Item Name: Crosstube Low Standard Fwd

Sequence ID/ Work Center ID	Operation Description	Set Up/ Run Hours	Tool ID	Tool #	Plan Code	Accept Qty	Reject Qty	Reject Number	Insp. Stamp
Draw Nbr	**Revision Nbr**								
D212-664-147	Rev B (DEO)								MCJ 13-02-01
100		0.00							
100	DOCUMENT CONTROL					1			
DC	**Memo**	0.00							
Document Control	Photocopy bluefile and create labels as per PPP D212-664-107 D6019-128 (ID = 2.125") = CHG 002								
110		0.00							
110	Packaging								
Packaging	**Memo**	0.00							
Packaging									MO 13/01/09
120		0.00							
120	BENDING MACHINE - CROSSTUBES								
CNC Bend 2	**Memo**	0.00							
CNC Alpha 160 Bender	Bend tube as per Dwg D212-664-107 using CNC bender program 212-107								MO/RM 13-01-09

DRAWING NO.	TITLE	REV.	DART AEROSPACE LTD	D.E.O. NO.	SHEET NO.	SCALE
D212-664-147	CROSSTUBE ASS'Y (205 LOW FWD)	B	ENGINEERING ORDER	D212-664-147-B-1	SHEET 1 OF 1	NTS

PURPOSE:
REPLACE MAGNOBOND WITH PROSEAL.

D212-664-147/-147B
ASSEMBLY DETAIL B

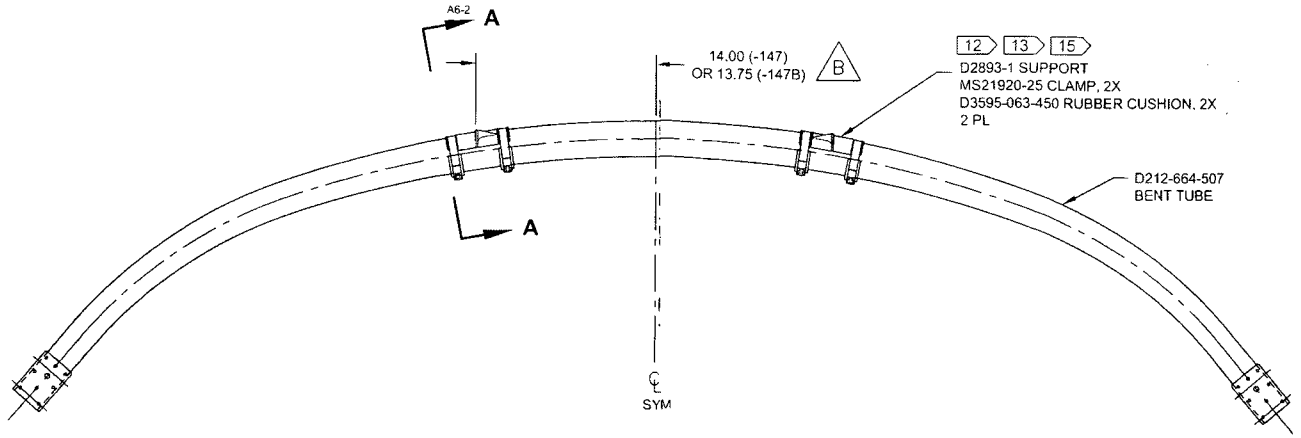
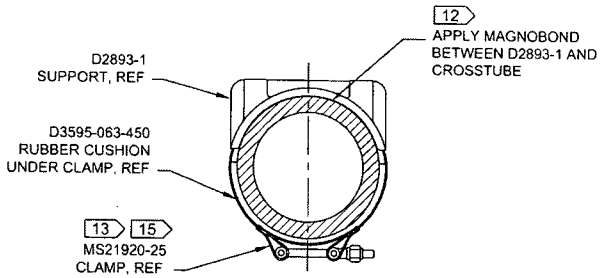
NOTE 12 & 15, SHEET 1 IS AMENDED AS FOLLOWS:

12) TO INSTALL D2893-1 SUPPORT: ABRADE MATING SURFACE OF SUPPORT AND CROSSTUBE WITH 180-GRIT SANDPAPER AND REMOVE RESIDUE WITH MEK (OR EQUIVALENT). APPLY A 0.04" TO 0.07" THICK LAYER OF PROSEAL 890 CLASS B-2 (OR AMS-S-8802 CLASS B-2) SEALANT TO MATING SURFACE OF SUPPORT.
